Proc Folder: 1217778
Doc Description: Addendum 2-Ditch, Pipe,and Asphalt Repair and Maintenance
Reason for Modification: Addendum No. 2
Proc Type: Agency Master Agreement

1. To attach revised specifications.
2. To attach vendor questions with agency responses.
3. To attach revised Attachment A Pricing Page.

THE WEST VIRGINIA DEPARTMENT OF TRANSPORTATION- BUDGET AND PROCUREMENT DIVISION - THIS IS AN AGENCY OPEN ENDED CONTRACT FOR DITCH, PIPE, AND ASPHALT REPAIR AND MAINTENANCE BY VENDOR PER THE ATTACHED DOCUMENTS. QUESTIONS REGARDING THE SOLICITATION MUST BE SUBMITTED IN WRITING TO dotprocurementtechques@wv.gov PRIOR TO THE QUESTION PERIOD DEADLINE CONTAINED IN THE INSTRUCTIONS TO VENDORS SUBMITTING BIDS.

THE WEST VIRGINIA DEPARTMENT OF TRANSPORTATION DIVISION OF HIGHWAYS
SHOULDERS AND DITCHES

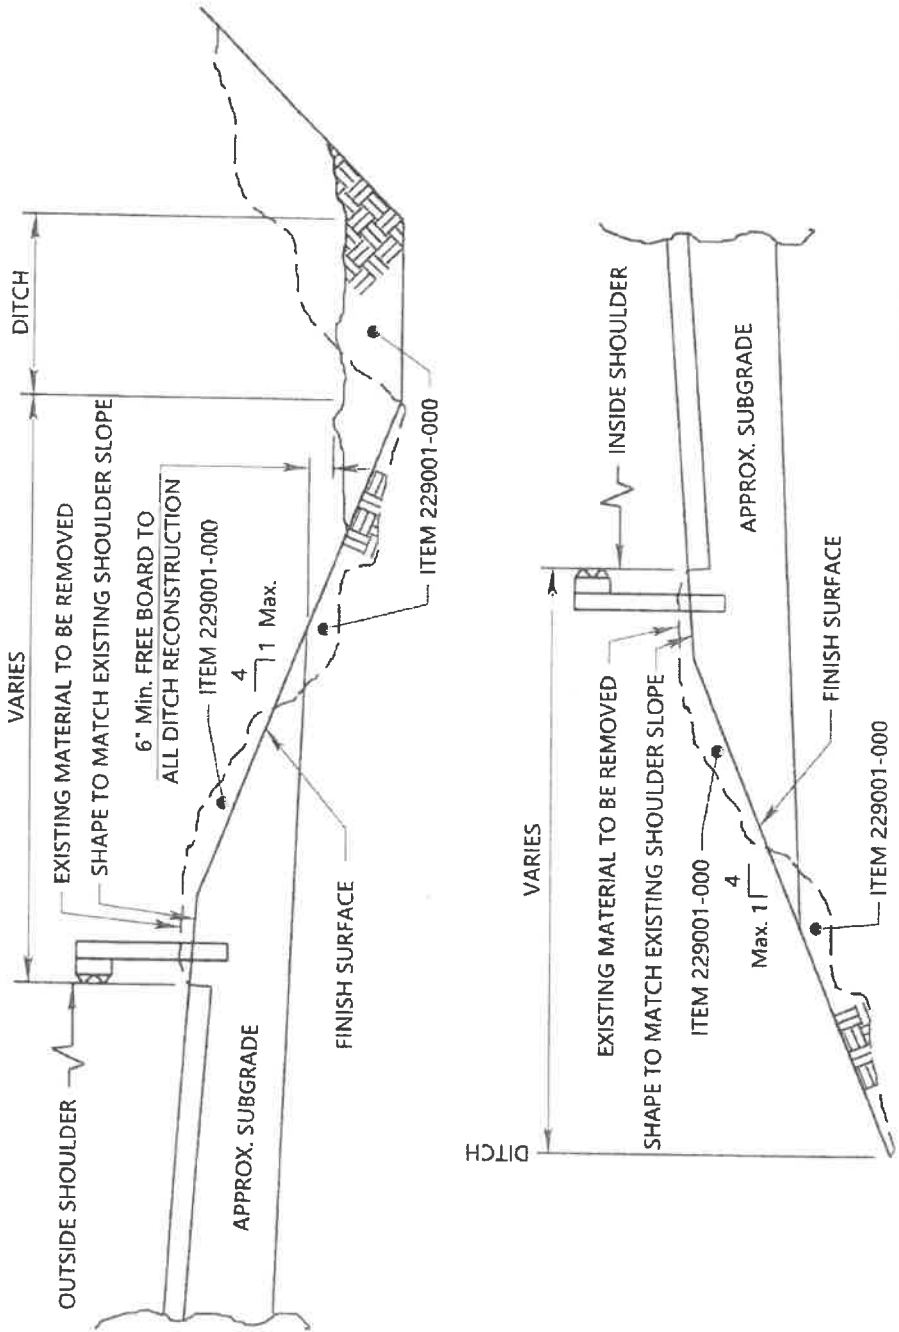
Detail on p. 37 for ditching shows grading the shoulder at a 4:1 max slope. Will this be required in areas where the existing ditches are steeper than 4:1? In some cases, this could create large amounts of earthwork and additional right of way.

If current site conditions prevent the shoulder and ditch from being shaped per the contract specifications, the District Engineer or their designee shall provide the required shoulder and ditch geometry during the delivery order or prior to commencement of work on the section of ditch line in question.

EXHIBIT 1, Page 5, Repaving Pipe Trenches in Paved Shoulder - Type F

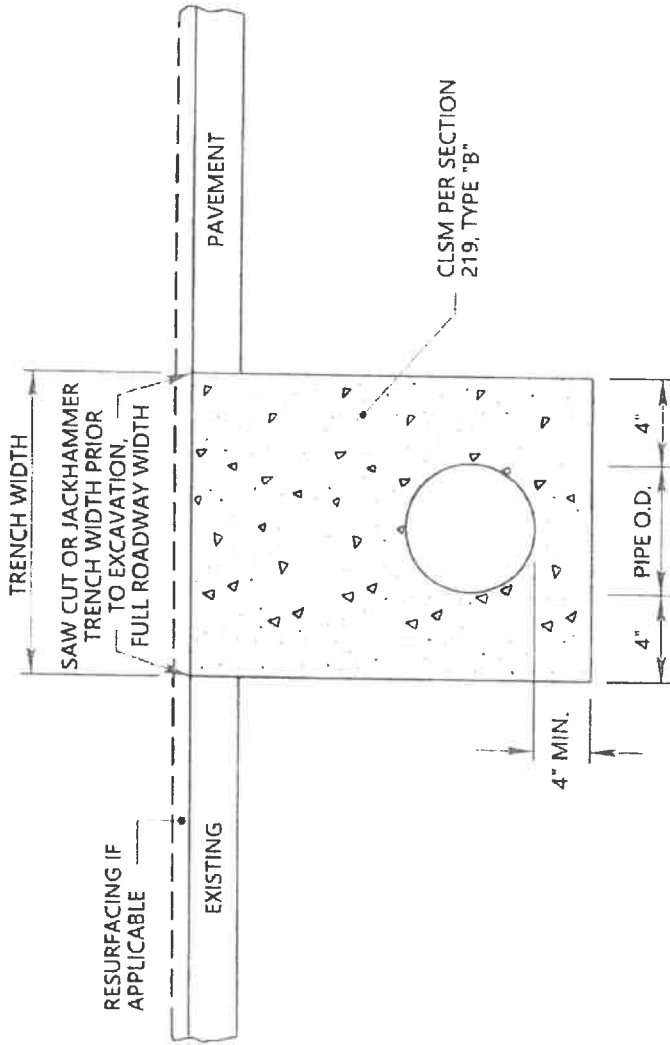
We have revised the Contract Specifications section 3.2.3.1, 3.2.3.2 to clarify that backfill materials are to be provided by the vendor. To summarize these changes:

- All trench backfill materials, with the exception of CLSM, is to be included in the bid price for Contract Items 15-23.
- Contract Item 24, Pipe Repair/Replacement backfill for F Trench (material + delivery first 5 miles), is for the CLSM backfill material needed for Type F trench and includes the first five miles of haul in the vendor's bid price.
- Contract Item 25 – Additional Haul per truck load over 5 miles, Backfill for F Trench, was added to the contract to compensate the vendor for expenses related to the haul of CLSM over 5 miles.
